# ***FINAL ENVIRONMENTAL IMPACT STATEMENT (FEIS)***

## **PROPOSED 1000 TAYLORS LANE SUBDIVISION Village of Mamaroneck Westchester County, New York**

**Date FEIS Submitted: December 2, 2016; Revised December 14, 2016  
Date FEIS Accepted: December 14, 2016**

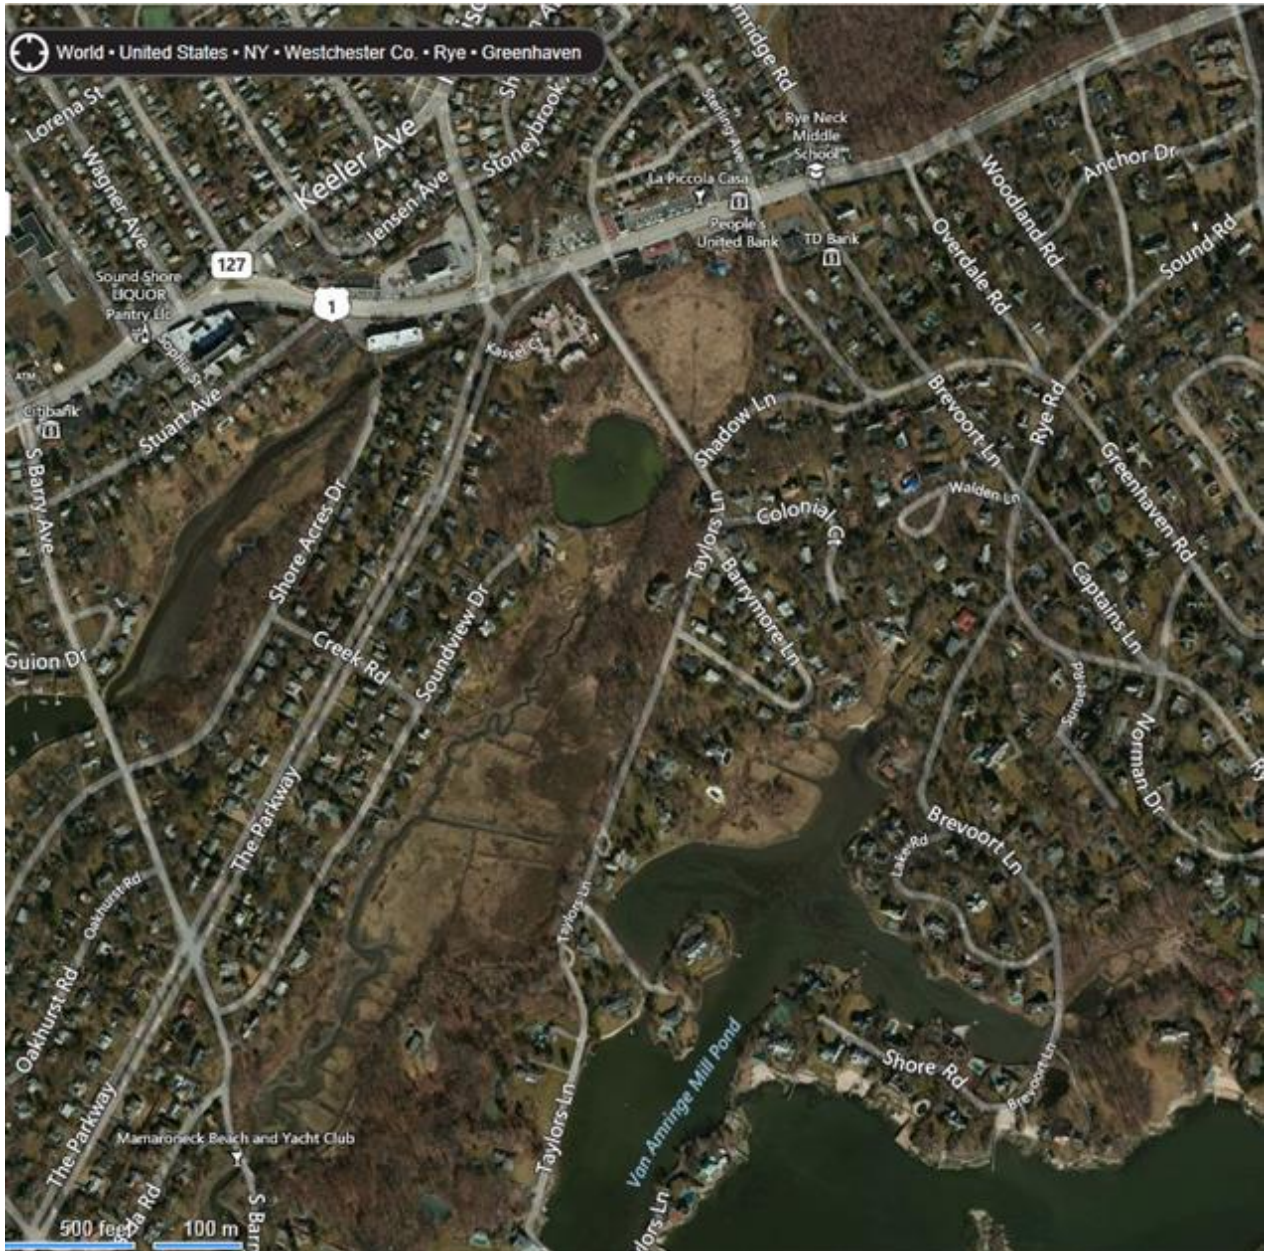
###### **Comment IV-A-2.1**

*As seen in this aerial photograph, in the Applicant's opinion, the addition of two new residences along Taylor's Lane is entirely consistent with the surrounding residential areas, including Barrymore Lane, Colonial Court and Soundview Drive.*

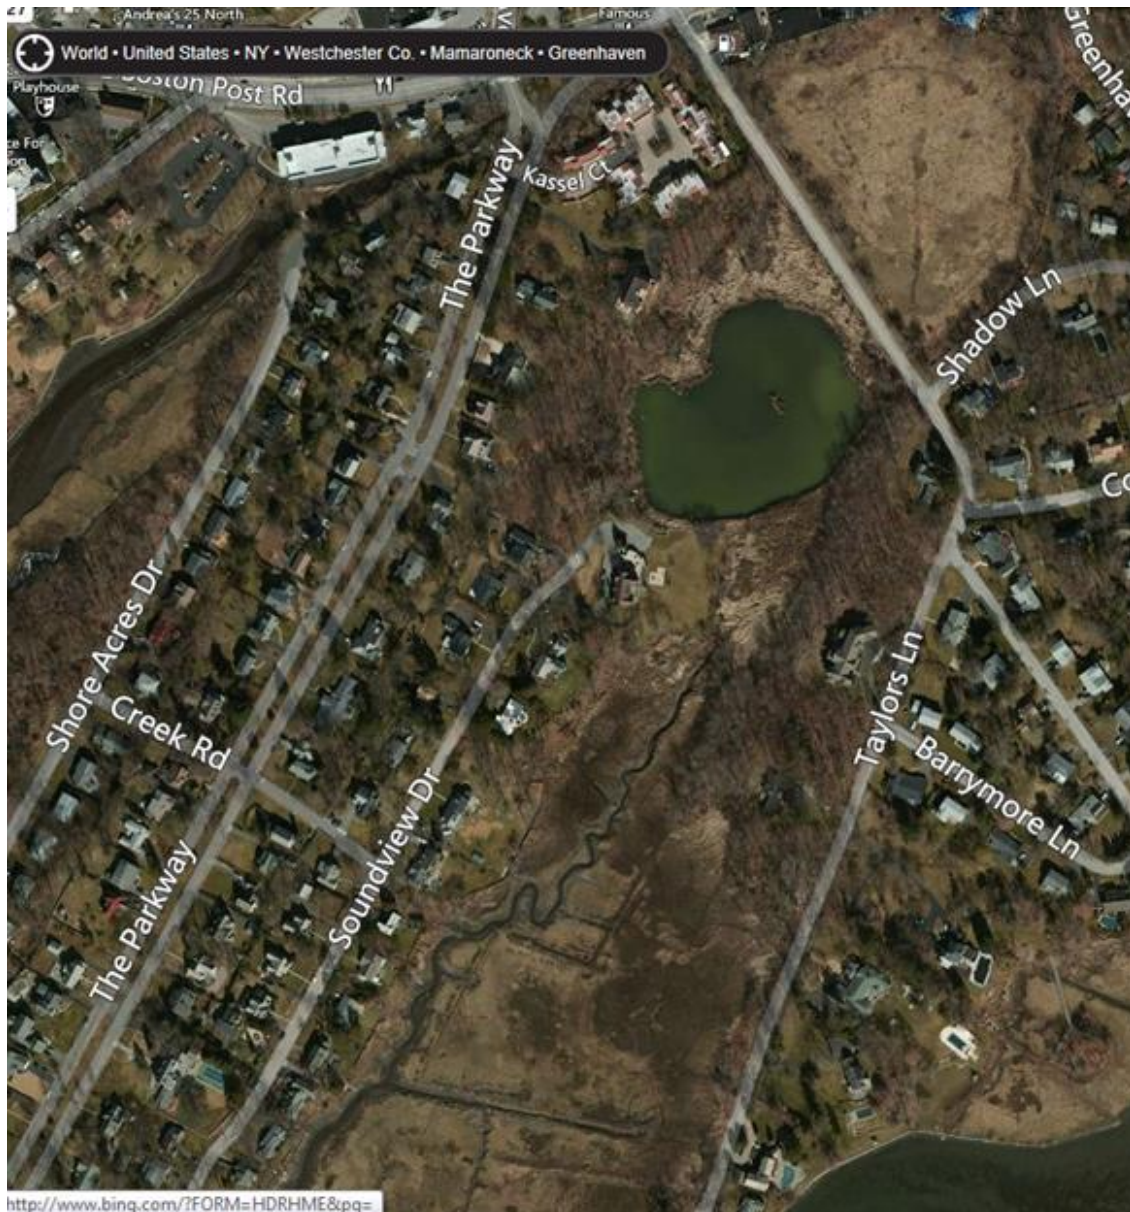
*"The proposed 3-lot subdivision would create lower-density residential properties compared with most of the surrounding patterns of development. The wetlands and wetland buffers on the properties will not be impacted or cleared, thereby retaining the character of the nearby tidal wetlands and the surrounding areas." (pg. 6) [pdf pg. 15]*

SI-22. “There has also been little analysis provided as to how the theoretical lower density development would impact current views from the adjacent CEAs and the residences located along Soundview Drive or The Parkway.”

*As seen in the aerial photograph provided in Response IV-A-2.1, most of the residences located along Soundview Drive are south of the proposed new lots, and will not have a direct line of sight. Similarly, the majority of the residences along The Parkway are separated from Otter Creek by the residences along both sides of Soundview Drive.*

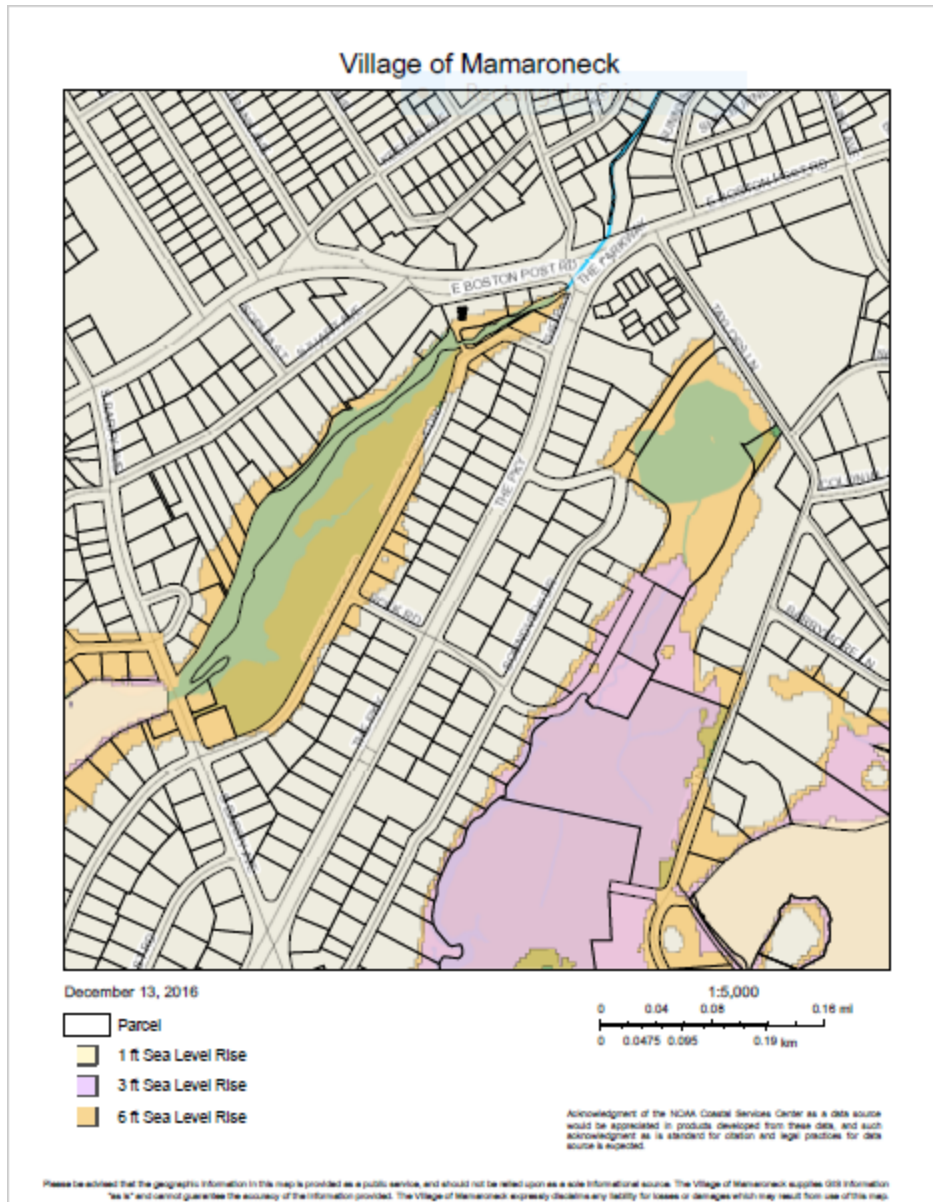
*This property is vulnerable to storm surge and rising sea levels. Global sea levels continue to rise steadily due to the melting of the polar glaciers and ocean expansion due to warming. By 2100, experts project sea level to rise in New York City and Long Island by as many as six feet (55-72 inches) under certain scenarios<sup>1</sup>. These rates are for the rapid ice melt scenario that is now considered by experts to be the most likely to occur, due to continued high emissions of greenhouse gases.*

*Under the site plans provided in the DEIS, with structures built at 12 to 18-foot elevations, future structures at this site could be inundated by storm surges in combination with future elevated high tides (such as the recent 11-foot surge).*

*DEC recommends that the Final EIS address the likely impacts of projected sea level rise on both the current and proposed structures and on the wetland adjacent areas. The Village may wish to require a larger set-back to insure adequate buffer for the freshwater and tidal wetlands and the Otter Creek Critical Environmental Area (CEA).*
